Re: Development Application 330/1617 - Proposed Argyle Quarry

Lots 1 and 2 DP 1094055

63 Curlewin Lane and 17033 Hume Highway, Boxers Creek

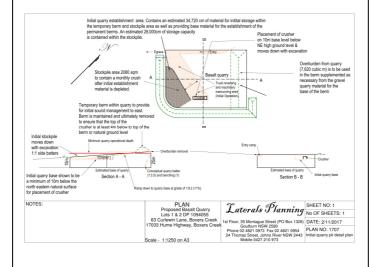
- Drainage works would be determined following detailed survey and engineering design as has been required by RMS in their concurrence letter.
- 3. The potential for Aboriginal Cultural Heritage item is not considered high as the acceleration lane follows an existing track which is shown by photograph opposite and is in a location which has been significantly disturbed from track construction and use and highway construction, noting that acceleration lane would be a 4m side sealed lane with 1m sealed verges (approximately as wide as the existing track). We have also conducted a new AHIMS search in relation to the sites which has not identified any sites or places of Aboriginal Cultural Heritage.

A full assessment of all matters would be conducted and documented for submission to the RMS in an REF for their Part V
